FLOOR DRAIN AND SLOPES	REVIEWED DRAWINGS HAVE BEEN RED LINED INDICATING A CHANGE TO MEET THE OBC. PLEASE REVIEW ALL PAGES TO ENSURE YOU ARE PROPERLY INFORMED OF CHANGES.

drawing title	
GENERAL NOTES & INDEX	
reference	
project no. 25-104	client reference number
sheet no.	
A - 001 02

drawing title	FLOOR PLANS DEMOLITION & RENOVATION
reference	
project no.	25-104
client reference number	
sheet no.	A-11002

project
CHALMERS PUBLIC SCHOOL
RENOVATION

NAME		DATE	OCEL METAL FAB	
DRAWN	G.W.	06/02/26	TITLE	
CHECKED			BEAM LINTEL	
ENG APPR				
MGR APPR				
UNLESS OTHERWISE SPECIFIED DIMENSIONS ARE IN INCHES ANGLES *XX*			SIZE	REV
2 PL *XXX 3 PL *XXXX			D	I
FILE NAME: Beam Lintel.dft				
SCALE:			WEIGHT:	SHEET 1 OF 1

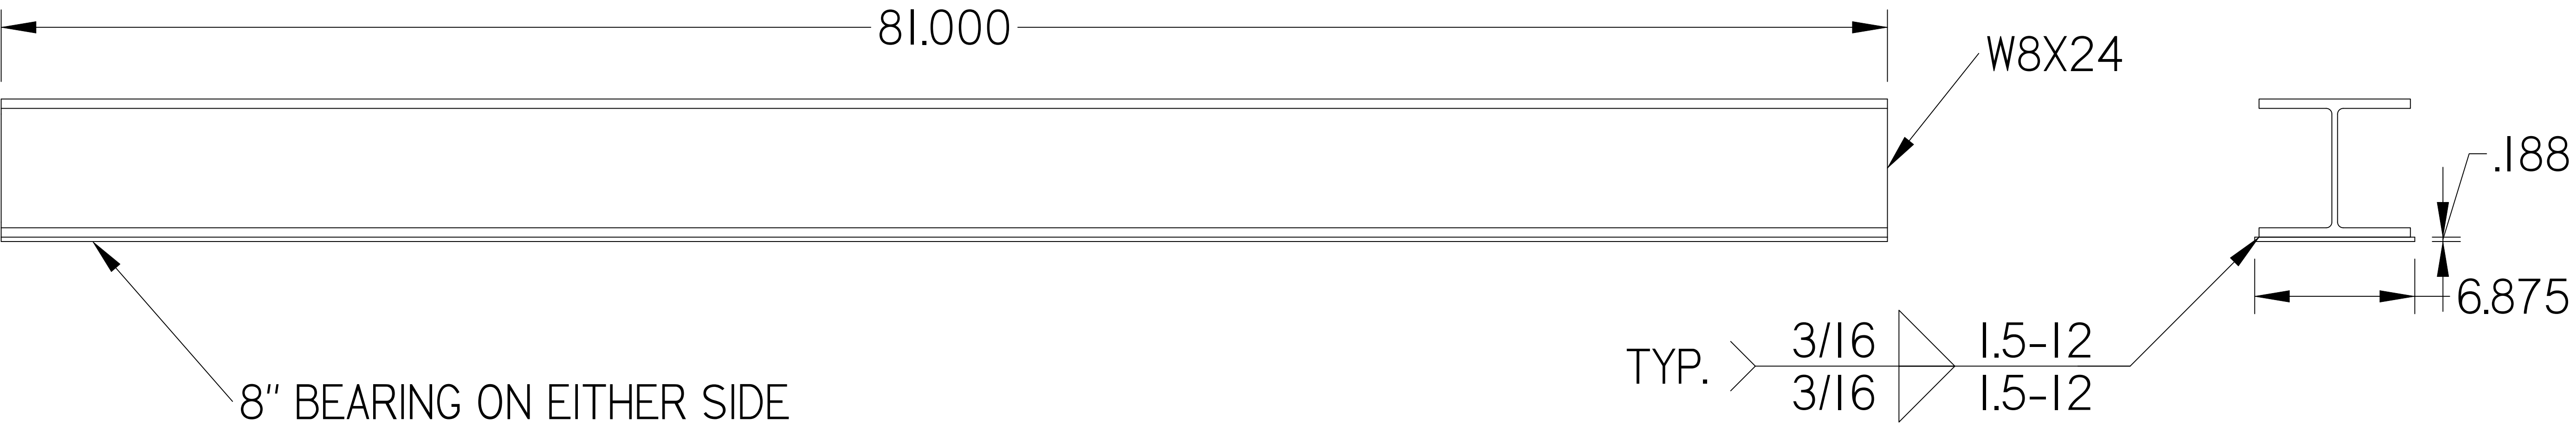
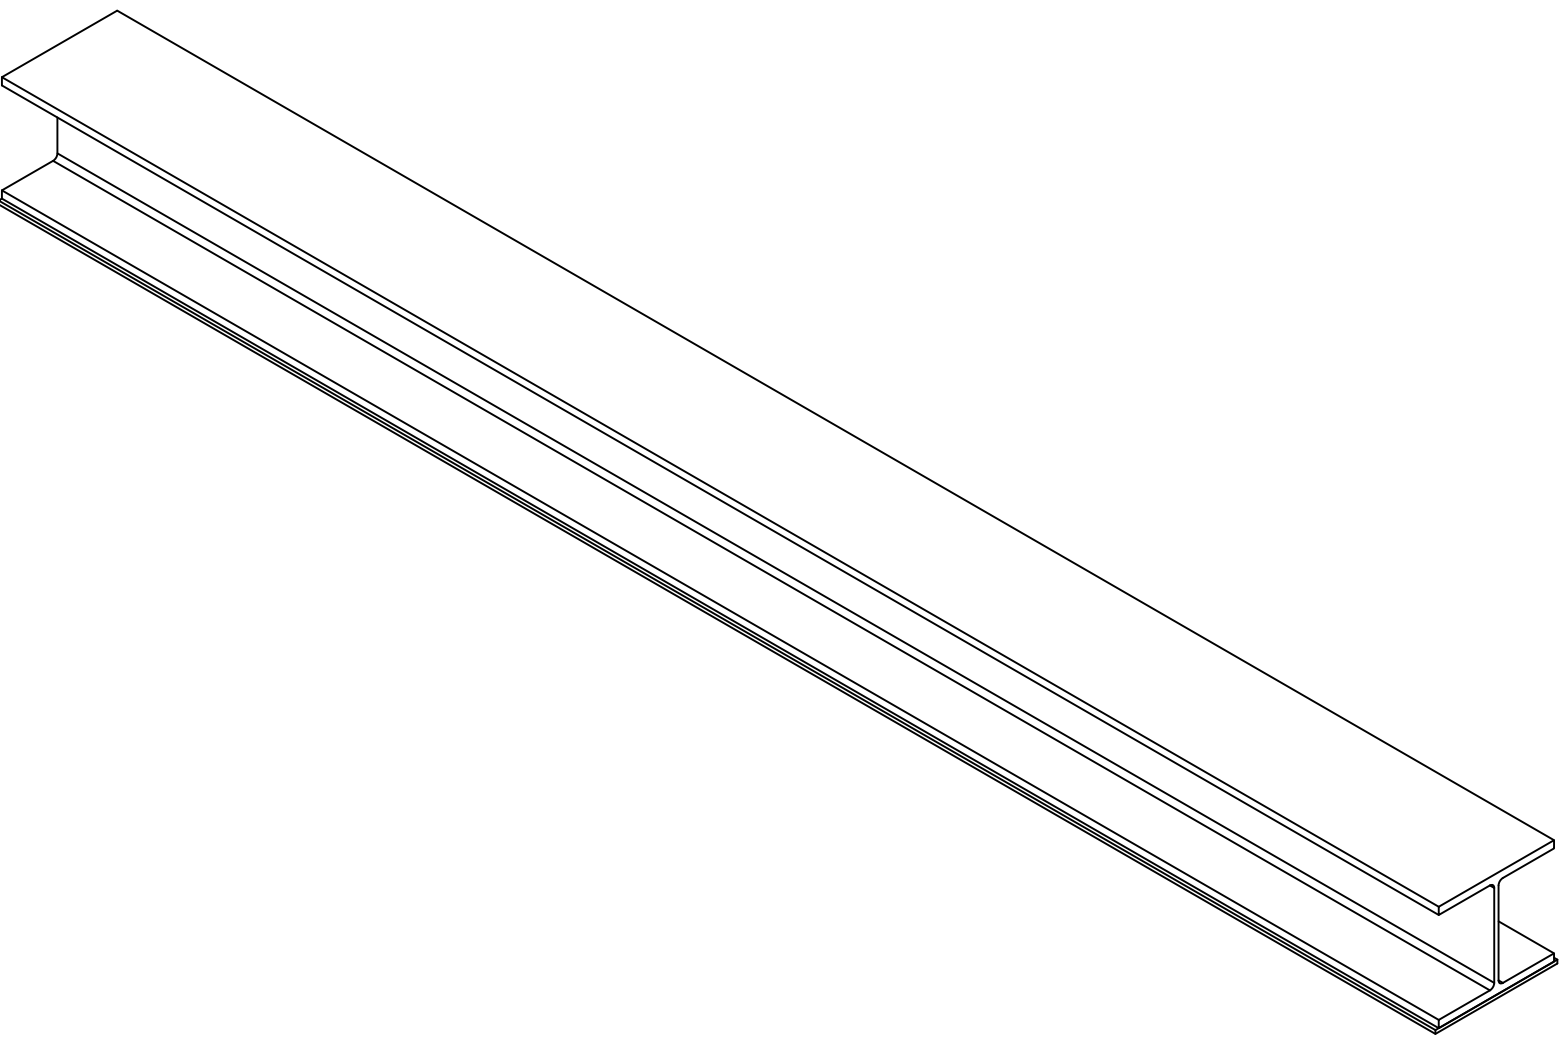
Reviewed as noted:
